Town of Milton

January 8, 2020

Runway 4R RNAV Study Requests

DISPERSION

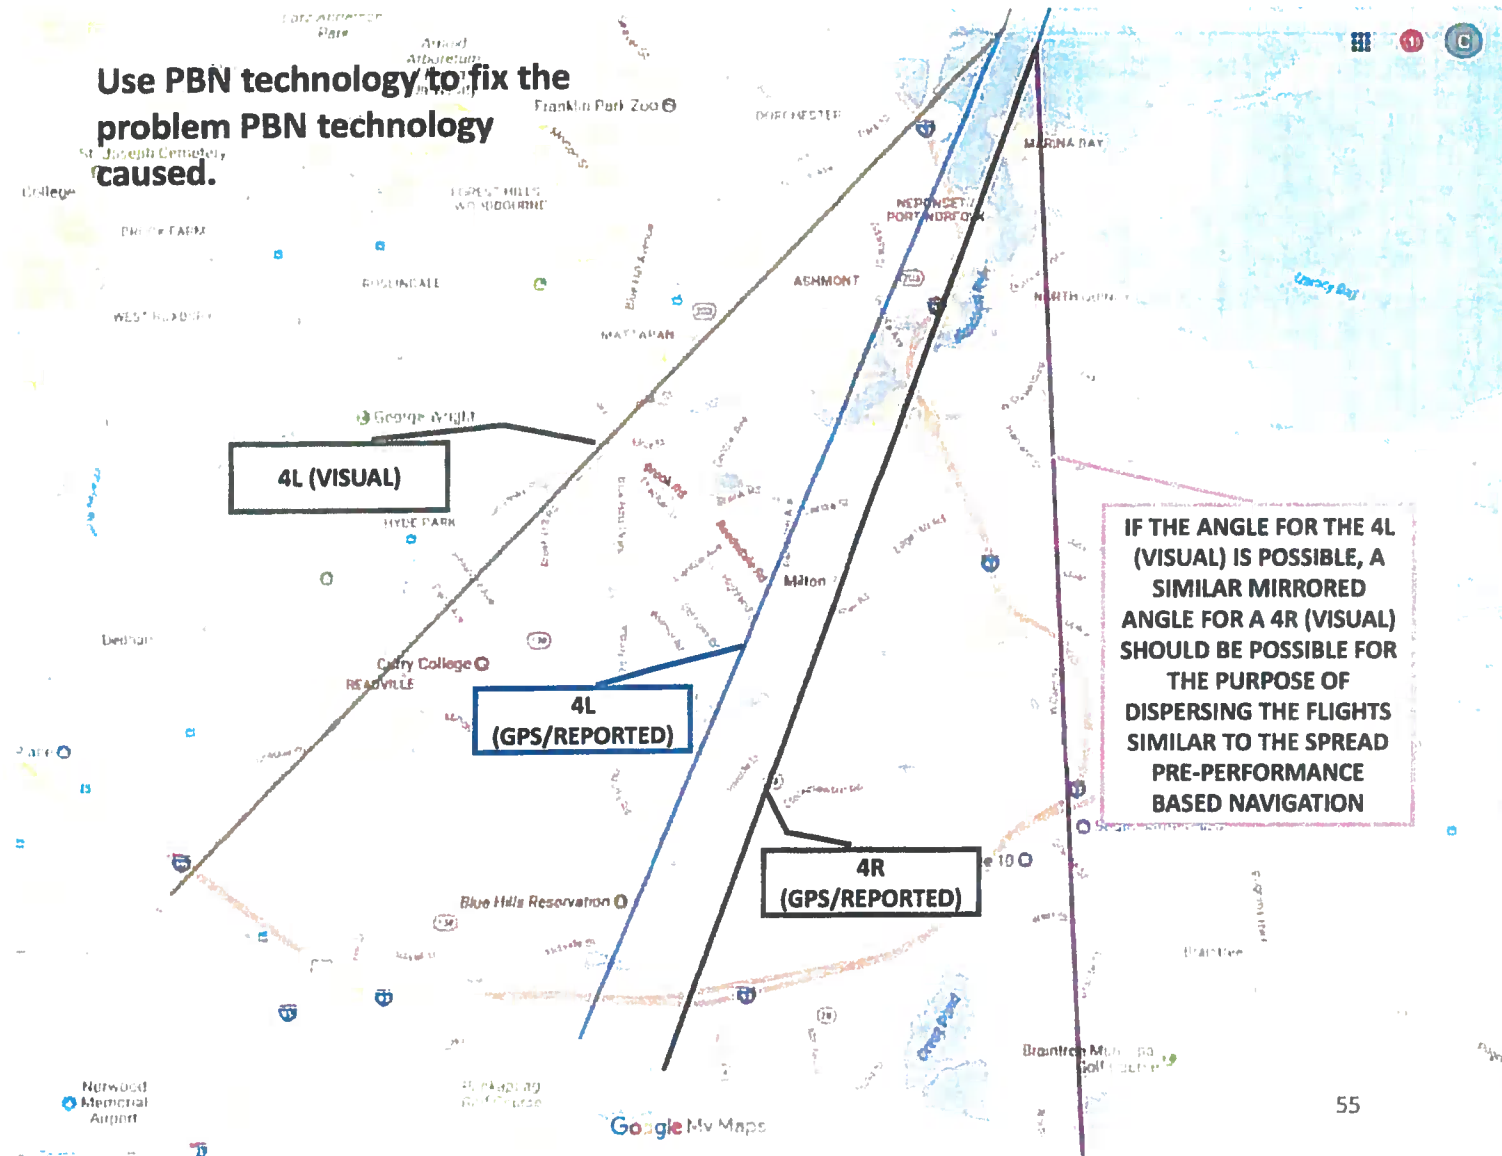
Why not “strings of the harp”, i.e., a “family of RNAV paths” within this triangle? We know that the FAA thinks it can have the two 4L RNAV paths shown. If these two are possible, then so are others to the east of 4R. 4L(Visual) meets up with 4R(GPS) at about 3.0 nm from the runway end.

Are greater angles at the intersection possible?

How many paths are possible?

How can multiple paths to the same runway ends be rotated?

Hourly? Daily?

Use PBN technology to fix the problem PBN technology caused.

DISPERSION

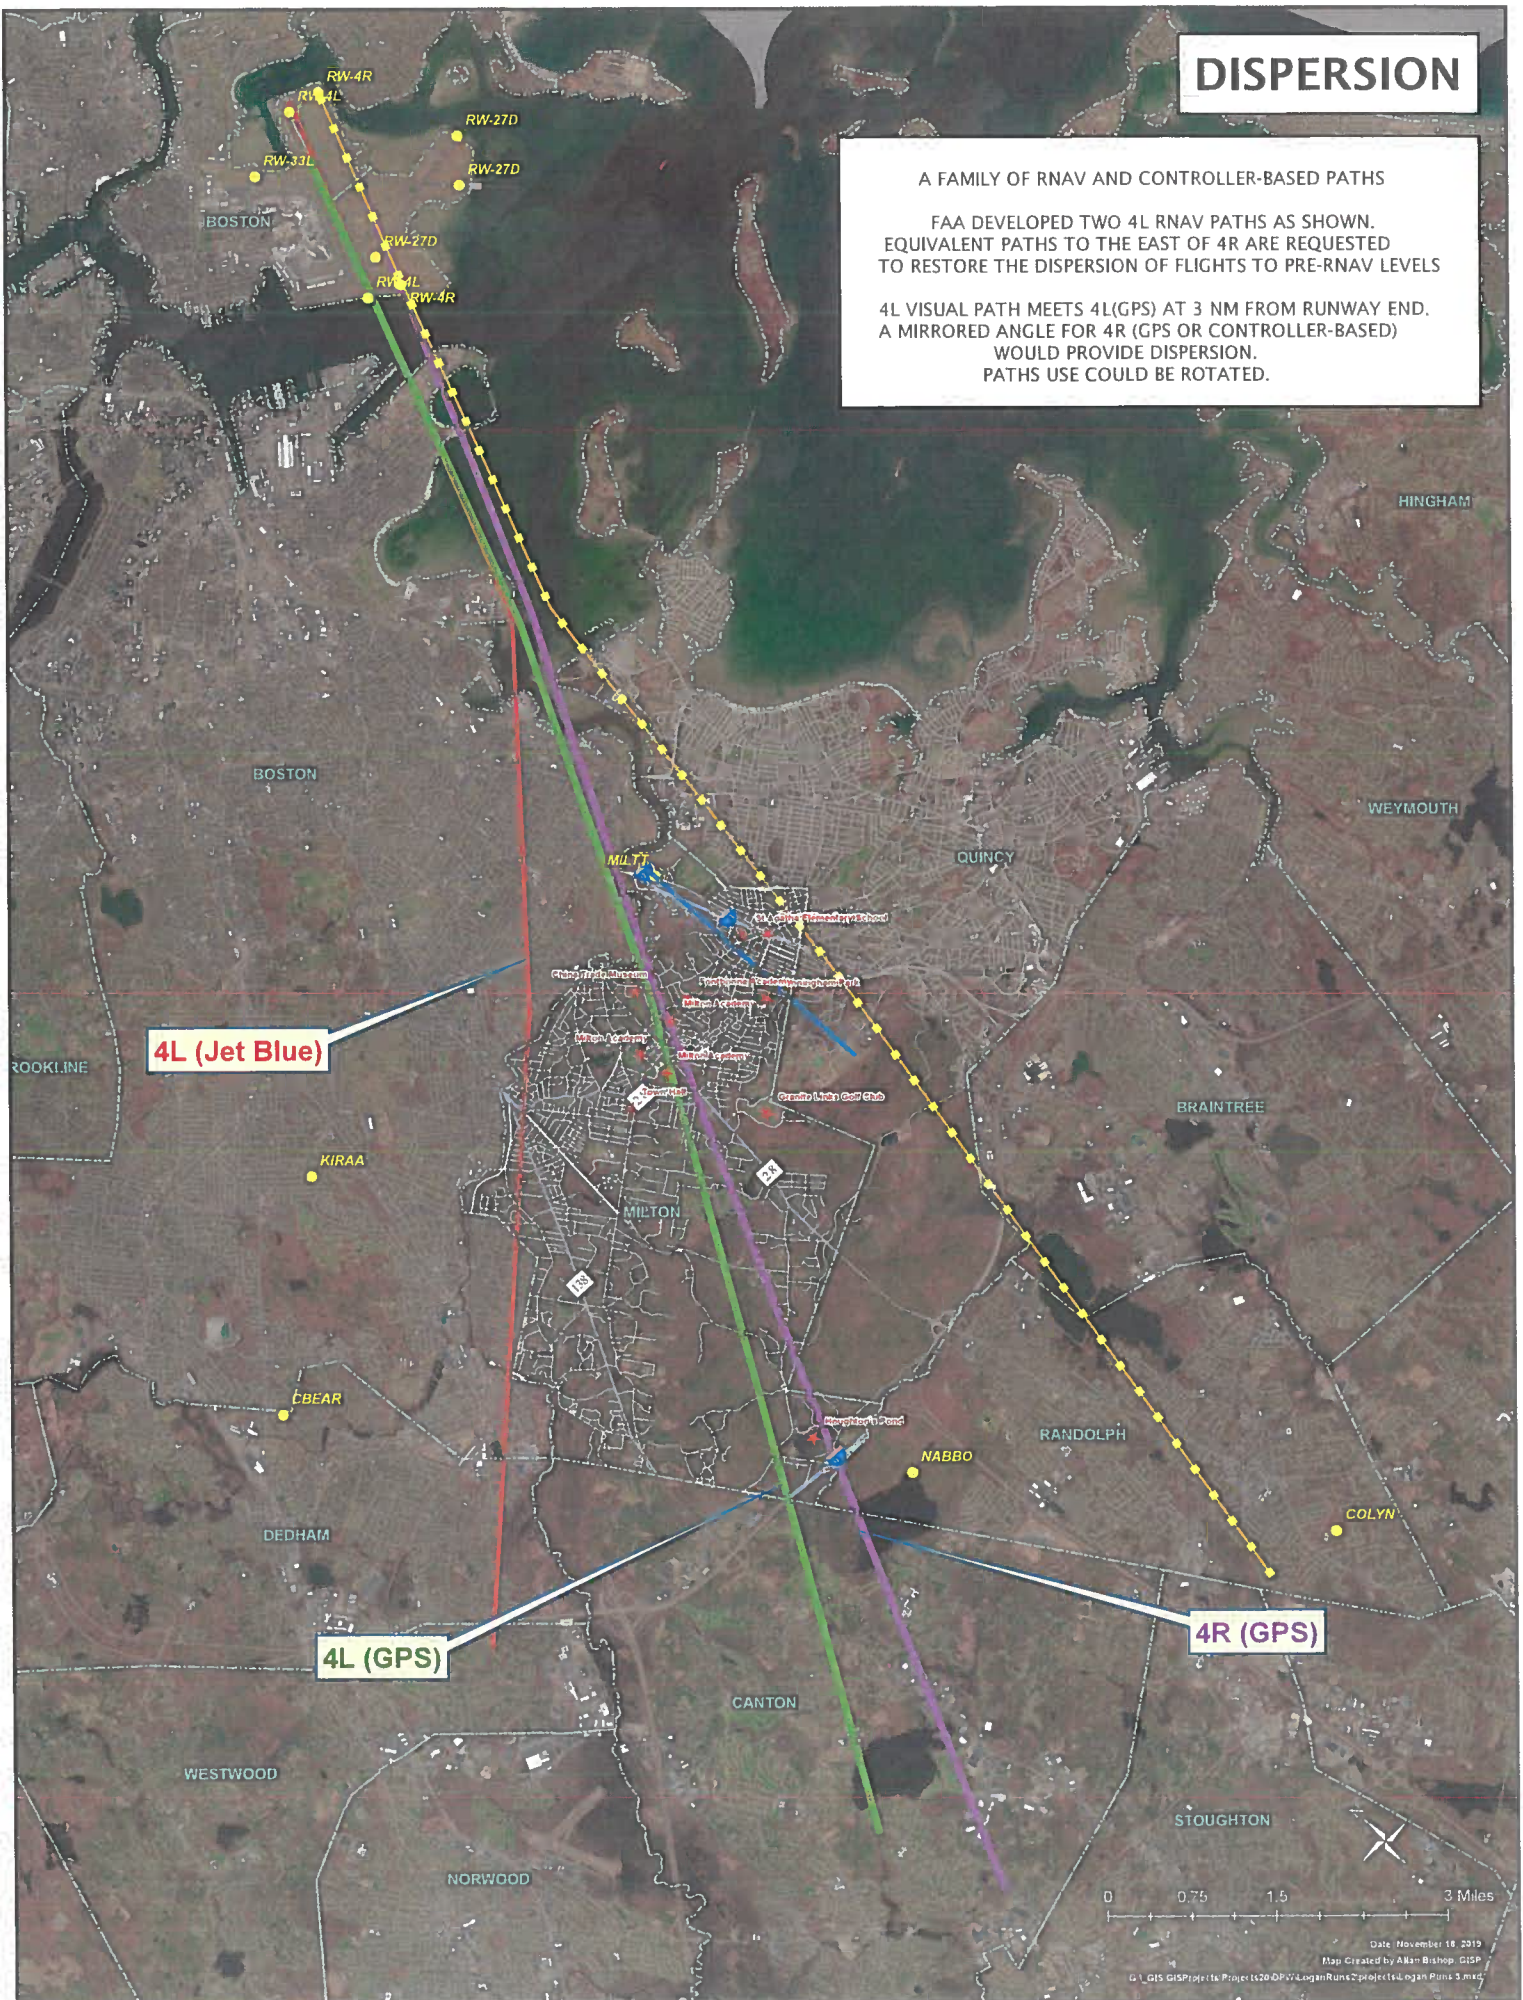
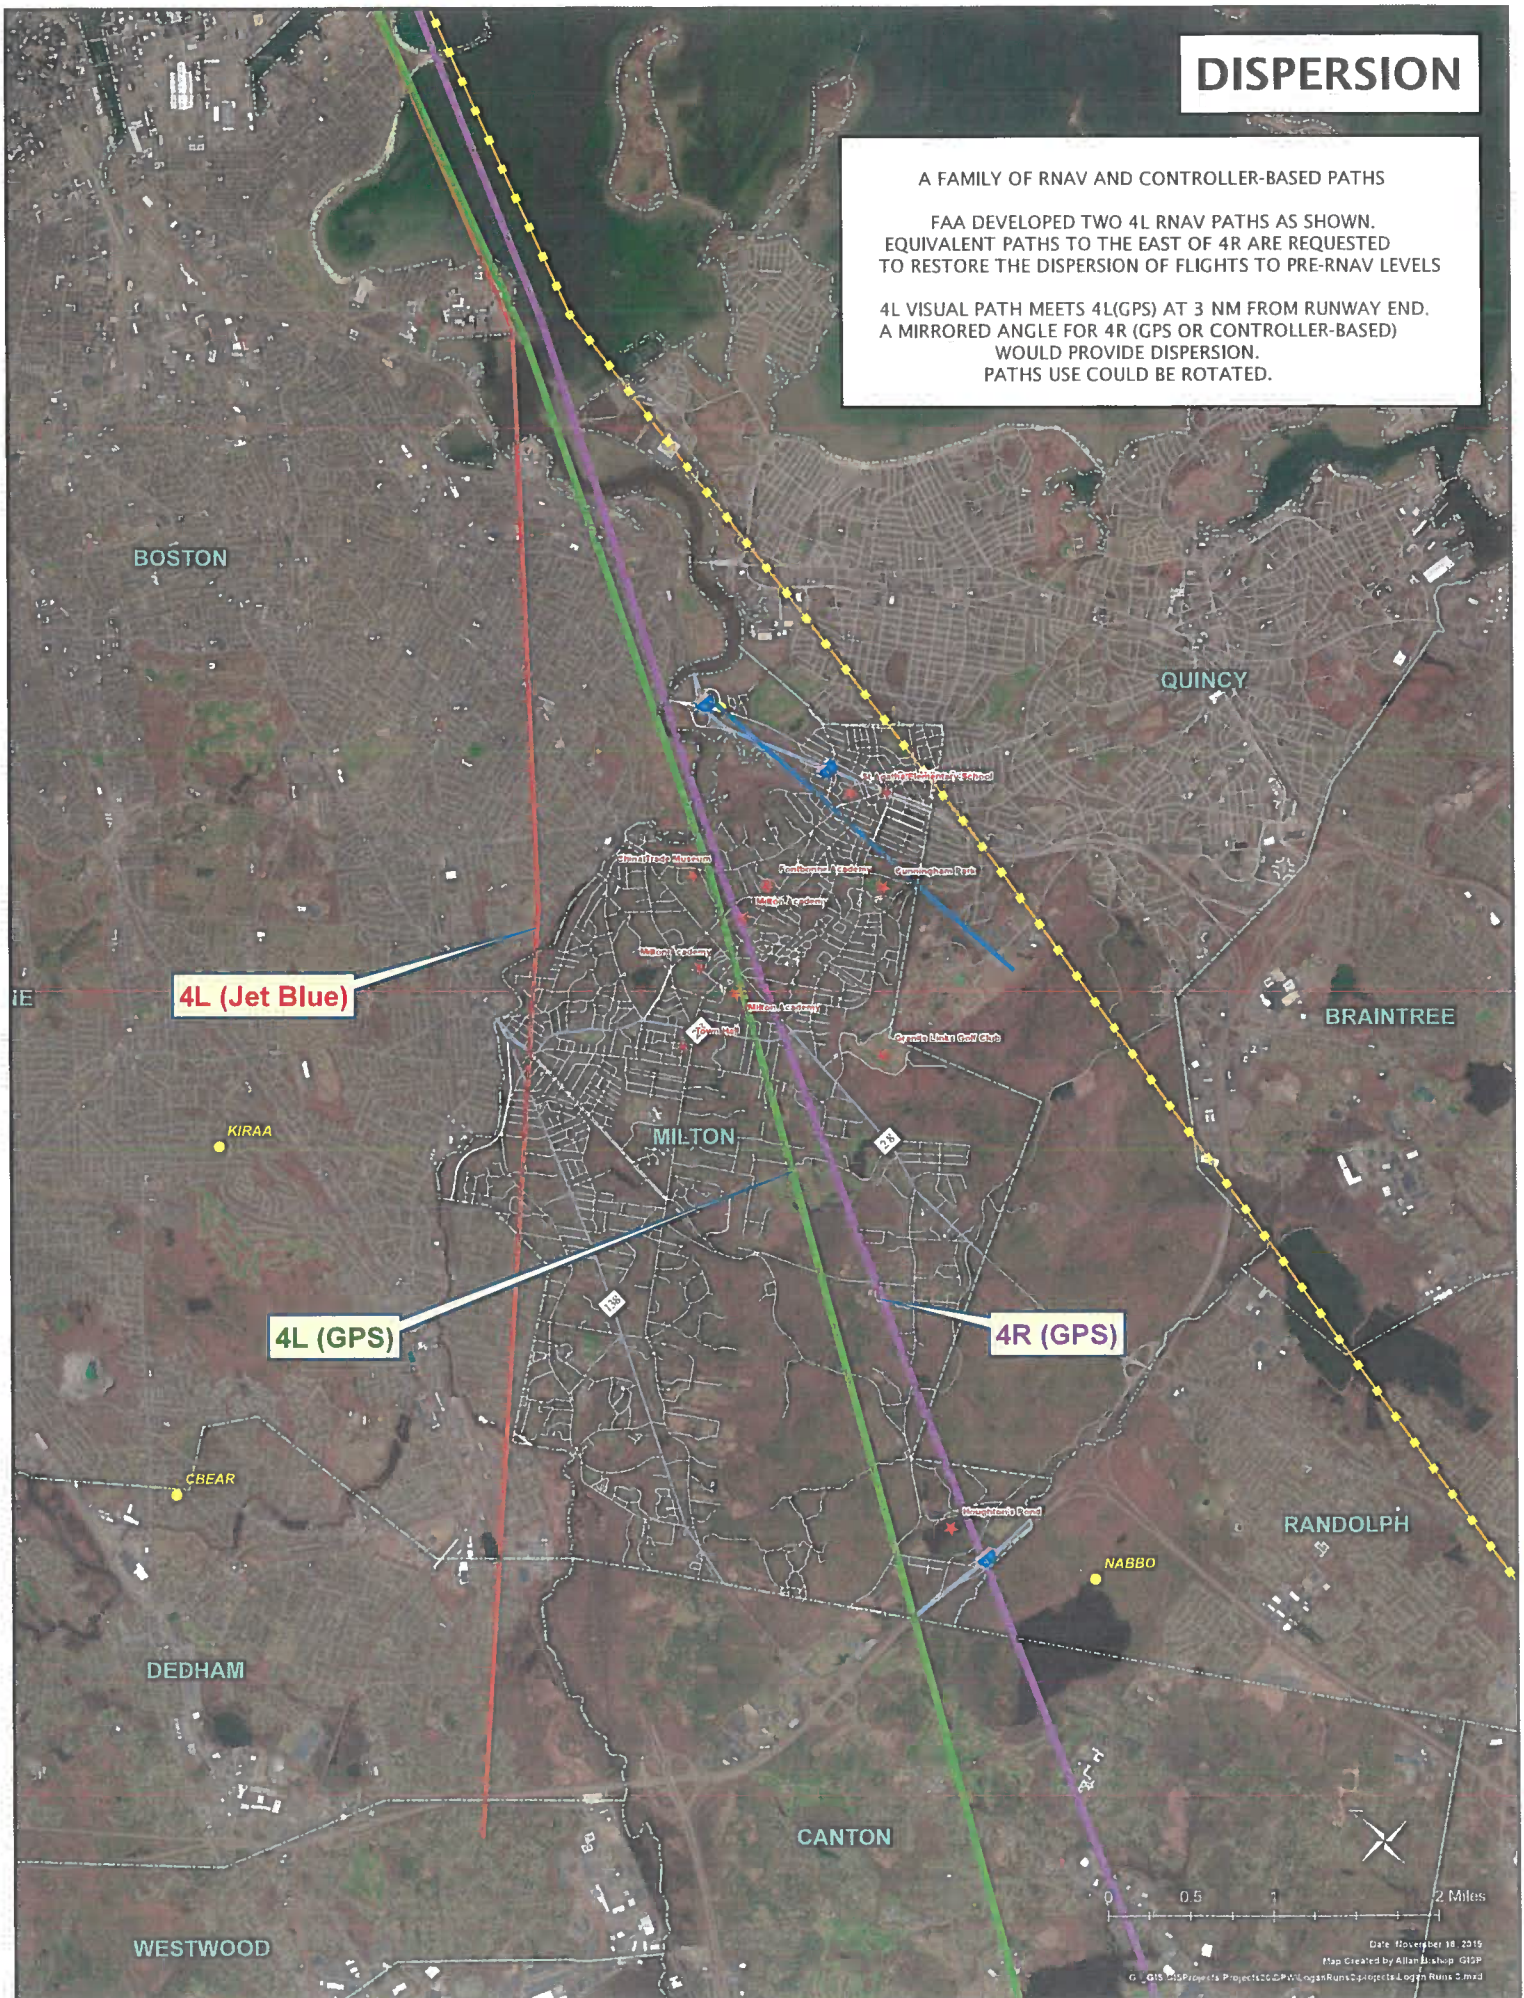
The dispersion slide (1,2,3) seeks analysis of an additional 4R RNAV path that mirrors the 4LJetBlue RNAV angle and its merging-in of flights (4LJetBlue RNAV merges-in flights from the northwest and west; the analysis of an additional 4R RNAV path would merge-in flights from the northeast and east similar to what occurred throughout the years prior to FAA's adoption of RNAV).

Two key issues are: flyability and a census block noise comparison with **pre-4R RNAV** overflights.

If the 4L JetBlue RNAV path, which merges-in planes approaching from the northwest and west is flyable and is assumed arguendo to be EA compliant (over densely populated West Milton, Mattapan and Dorchester), then an added 4R RNAV path to the east as illustrated in the dispersion slide with an equivalent (or lesser degree) angle (merging-in planes from the northeast and east) may be flyable and EA compliant. It would overfly areas overflowed before imposition of the 4R RNAV path, thereby restoring an element of 4R dispersion. Restoring dispersion restores noise burden sharing. We have requested evaluation of a renewed "string in the harp" within that ambit.

FAA DEVELOPED TWO 4L RNAV PATHS AS SHOWN.
EQUIVALENT PATHS TO THE EAST OF 4R ARE REQUESTED
TO RESTORE THE DISPERSION OF FLIGHTS TO PRE-RNAV LEVELS

4L VISUAL PATH MEETS 4L(GPS) AT 3 NM FROM RUNWAY END.
A MIRRORED ANGLE FOR 4R (GPS OR CONTROLLER-BASED)
WOULD PROVIDE DISPERSION.
PATHS USE COULD BE ROTATED.

Flight Tracks & LAMAX Noise Contours (dB)

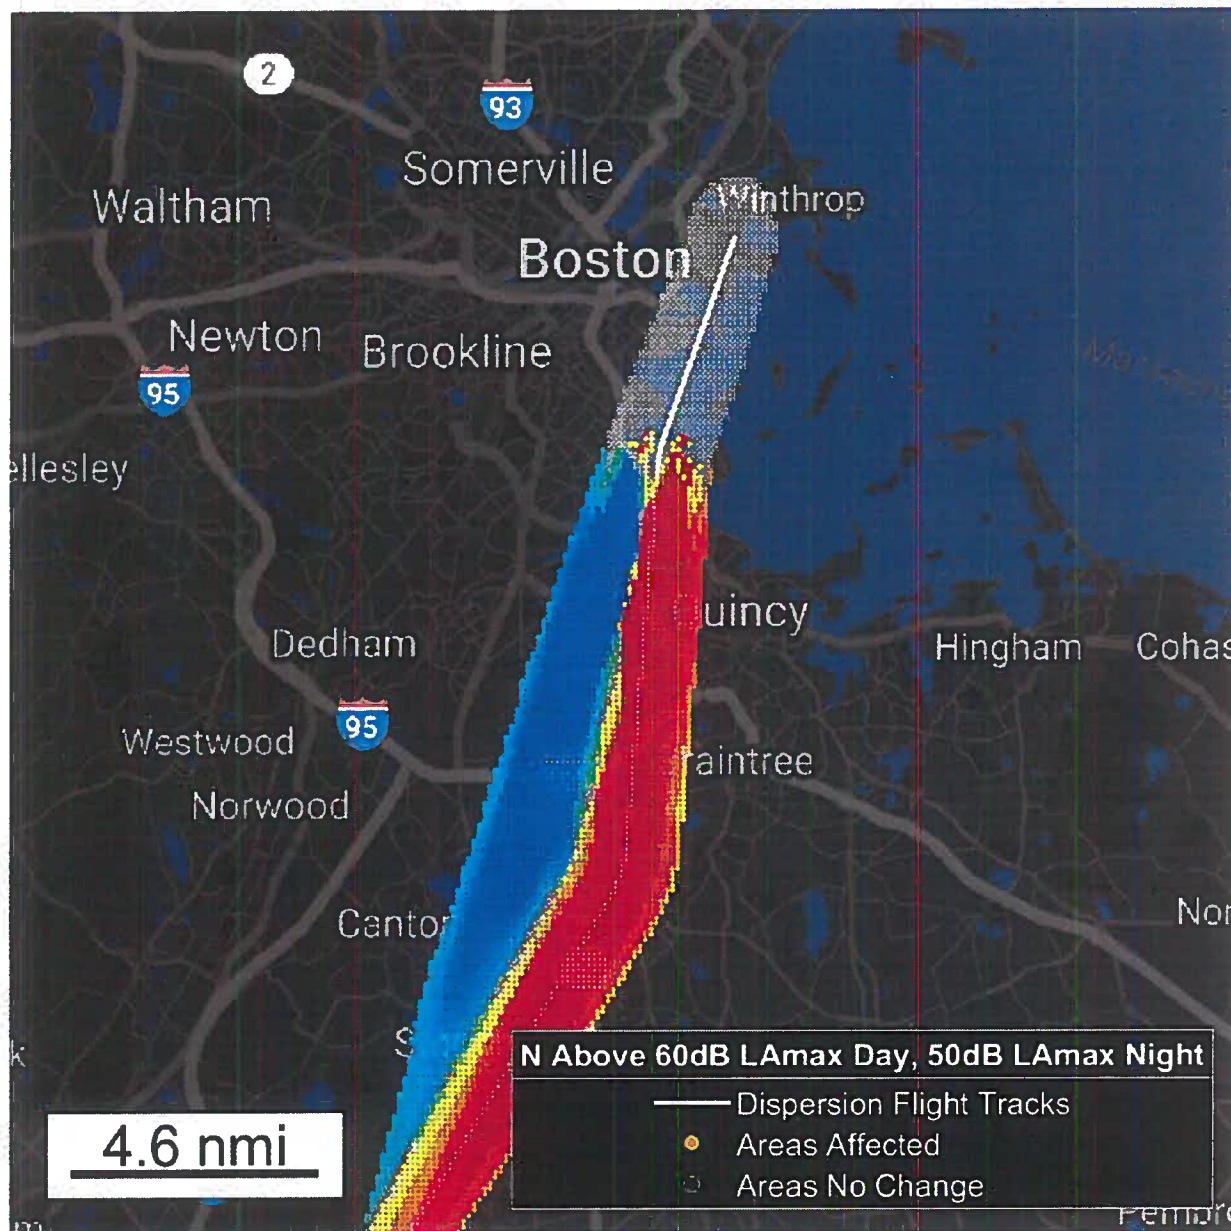
- Procedure within RNP criteria.
- Community support unclear.
- Possible flyability issues need to be tested.
- Air traffic merging concern with straight-in traffic.

4R RNAV Approach – Minimum Population Exposure From South

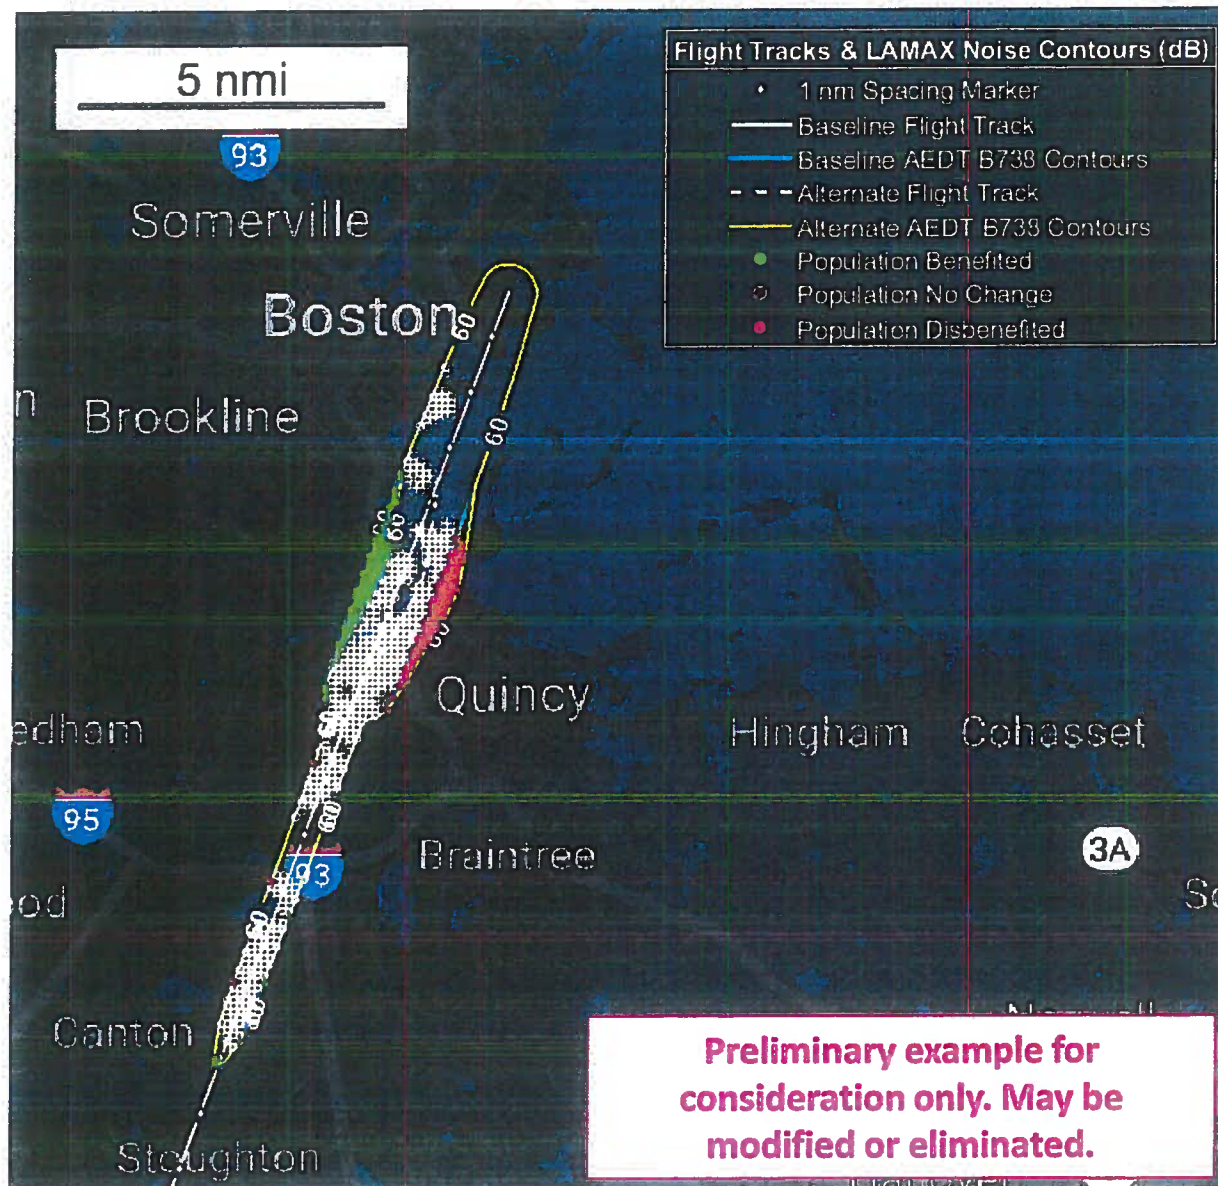
- Procedure within RNAV criteria.
- Community support unclear.
